City of Fayetteville Staff Review Form

SUBJECT: Lake Sequoyah Basin 3 Access Road Bid 17-56 Construction.
Approval and signature for the attached Change Order no. 3 to the construction contract with 81 Construction Group, Inc. for \$134,158.03.

PROJECT DATA		
Project Name:	Lake Sequoyah Basin 3 Access Road	Date of Request: 03/23/2018
Project No.:	Bid 17-56 Construction	Modification Date: Date Signed by the Mayor, City of Fayetteville
Ordinance/Resolution	Resolution no. 255-17	Resolution Date 12/05/2017

RE: Lake Sequoyah Basin 3 Access Road
Subgrade Recommendations:
New Roadway from Station 17+30 to 24+50
MCE Job# FY173348

Proposed Change Order no. 3

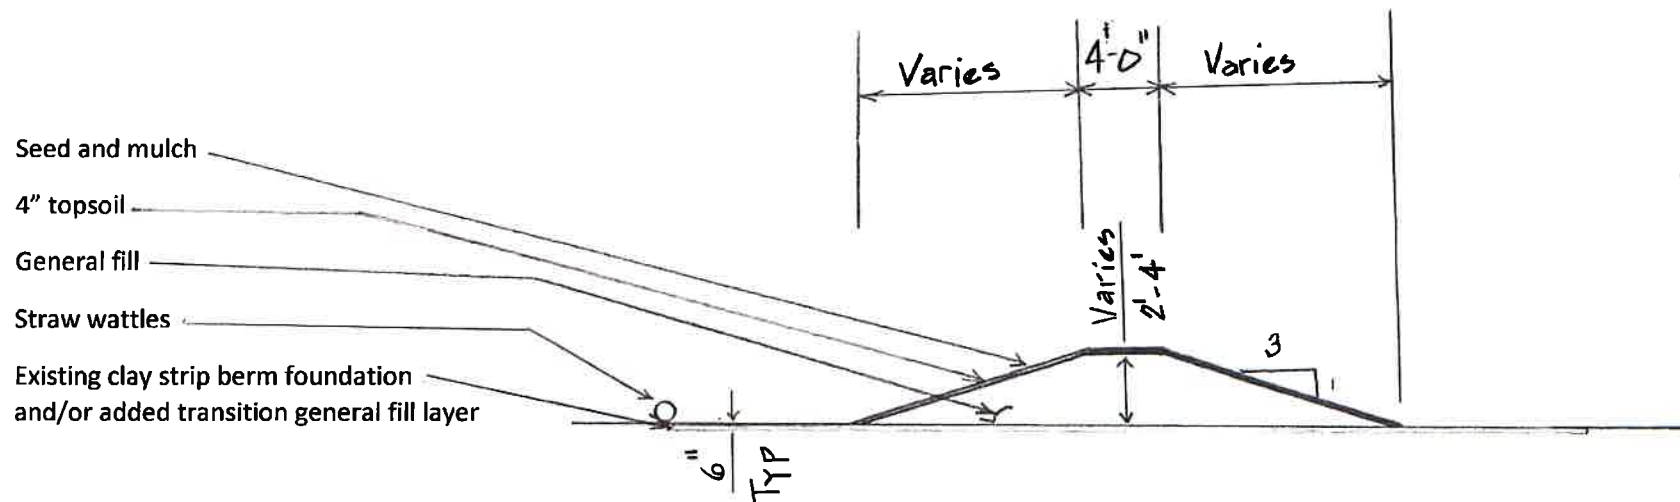
Construct earthen berm as indicated and as directed in the field on segments of the existing clay strip berm foundation and/or added transition general fill layer

Proposed Change Order no. 3

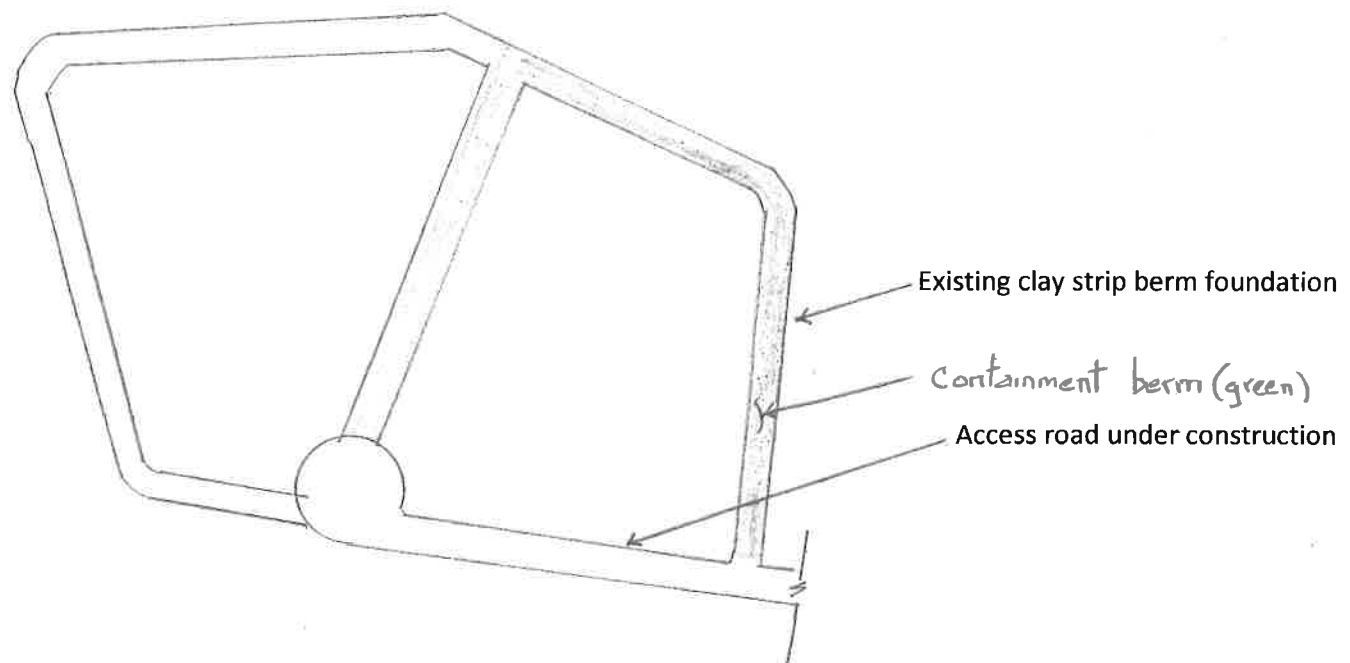
Construct earthen berm as indicated and as directed in the field on segments of the existing clay strip berm foundation and/or added transition general fill foundation

Contractor and Owner shall field verify dimensions and conditions
